RECAPP Facility Evaluation Report

Edwin Parr Composite Community School

B2418A
Athabasca

Evaluation Company: Francis Ng Architect Ltd.
Evaluation Date: September 26 2006
Evaluator Name: Francis Ng

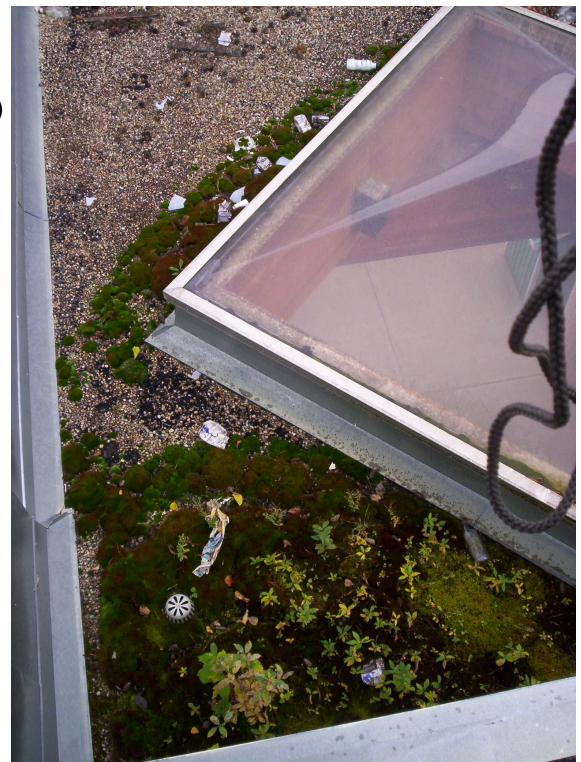
(1949) Original building, (1950) Addition, (1955) Addition, (1958) Addition, (1968) (gymnasium), (1984) Addition - (Flat Built-up Roof) has blisters, ponding, fish boning, worn out and cracked roofing.

Built-up roof has well established moss growing.

Replace with SBS roofing. (approx. 700 square metres)
